Constructed by - date	Evaluated by	Approved by - date	General Tolerances	Material	Finish, Ra	View	Scale
RA 08.06.2009			NS-ISO 2768-1	PE			1:20
Owner		Titel/Description		Revision			
		1409431_rev A		Container, rectangular 1000 litres			
Drawing number		Revision		Sheet size		Sheet	
625-34		A		A3		1(1)

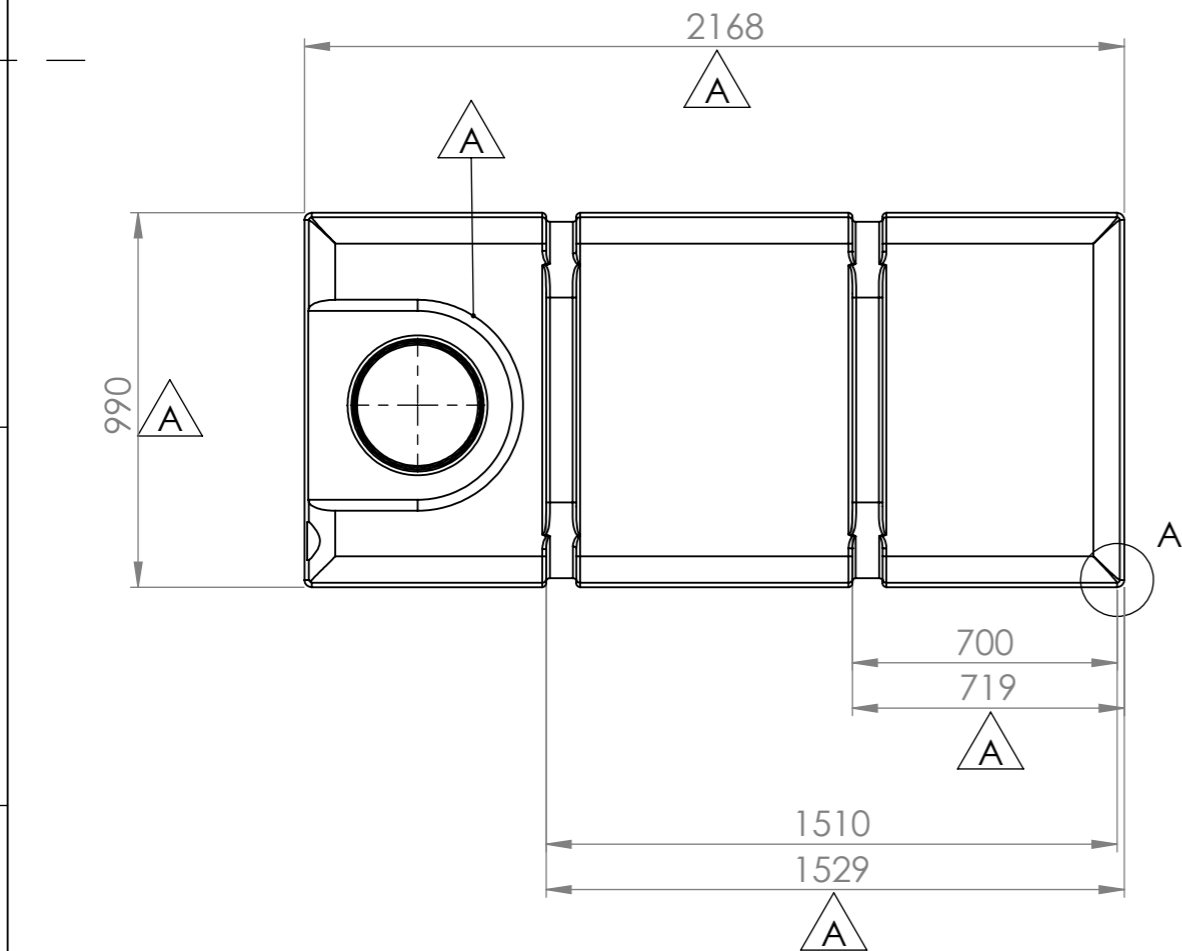
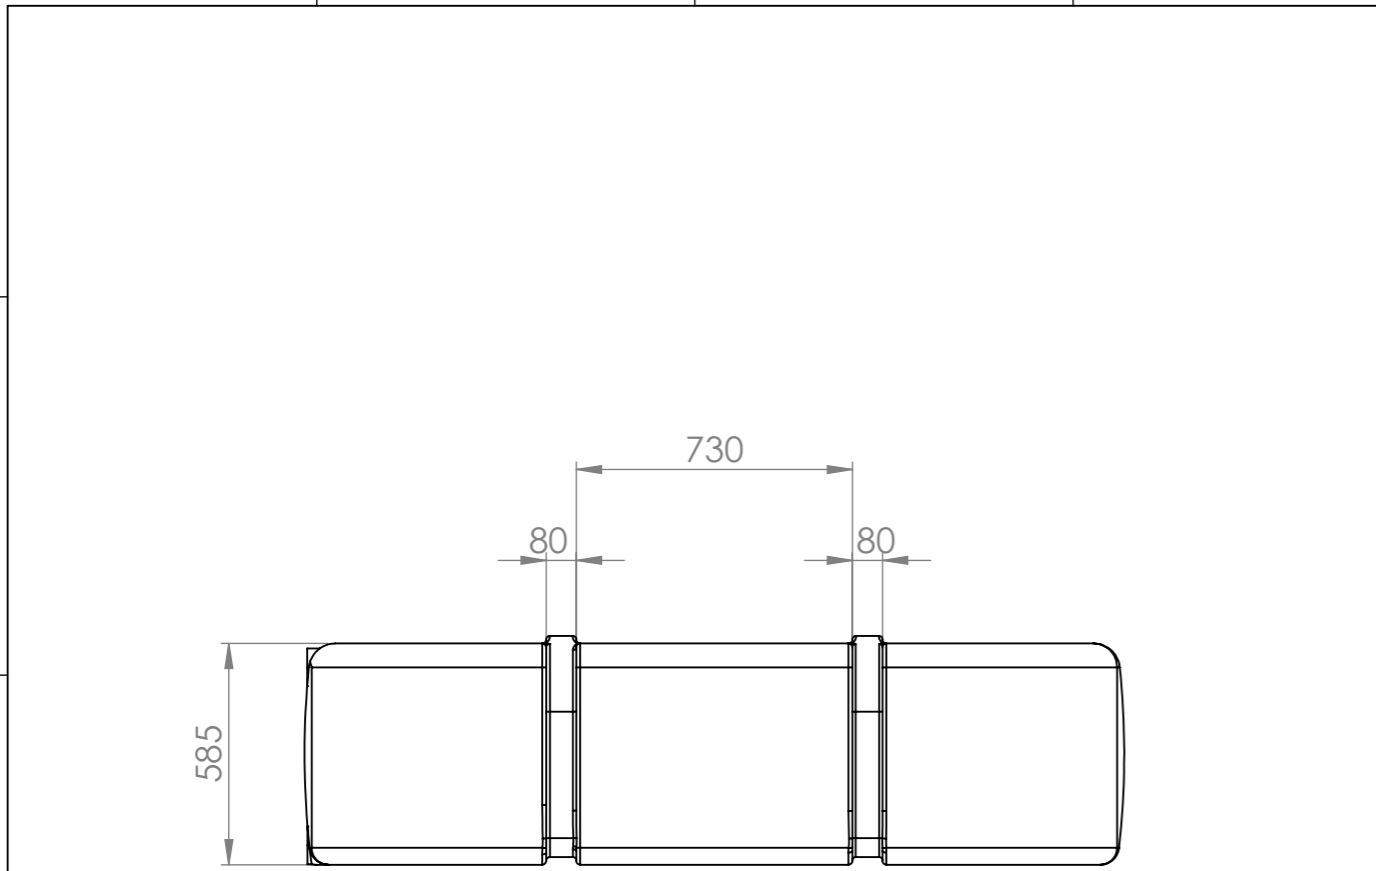
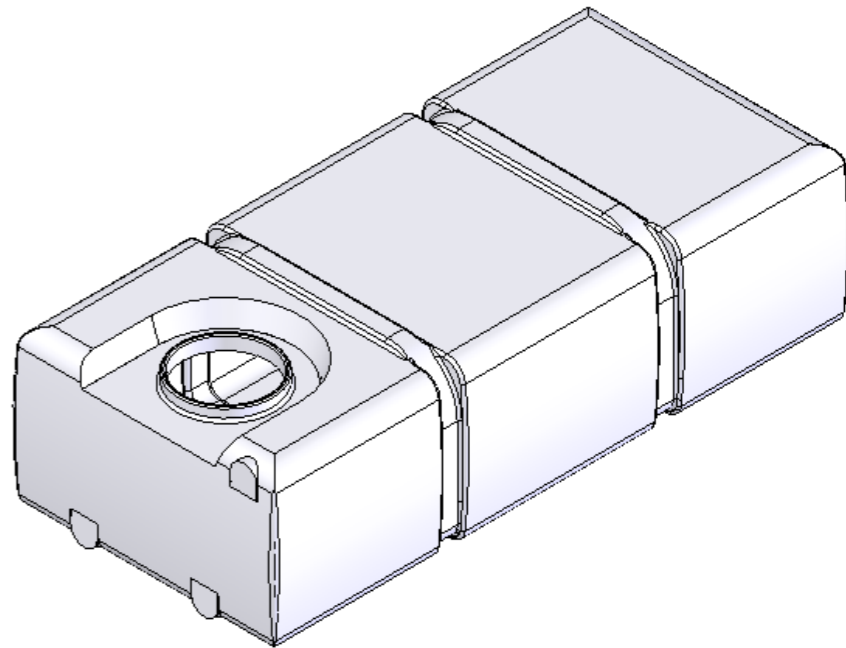
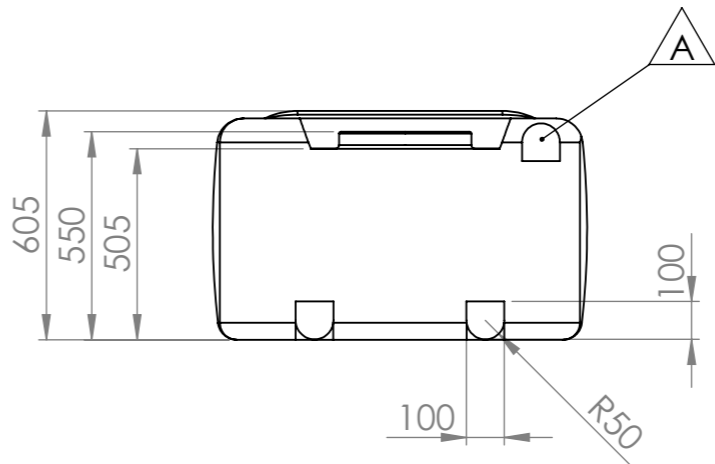
REVISIONS				
ZONE	REV.	DESCRIPTION	DATE	APPROVED
A	A	<ul style="list-style-type: none"><li>Total length reduced by 100mm (from 2268 to 2168).</li><li>Width reduced by 28mm (from 1018 to 990).</li><li>Distance between end of fillet at back end of the tank and left side of the right groove reduced by 20mm (from 720 to 700).</li><li>Distance between end of fillet at back end of the tank and left side of the left groove reduced by 80mm (from 1590 to 1510).</li><li>Added mounting surface in upper right corner at the front end of the tank.</li><li>Fillet removed at top edge of the lowering to the tank opening.</li></ul>	02.02.2015	
KFL
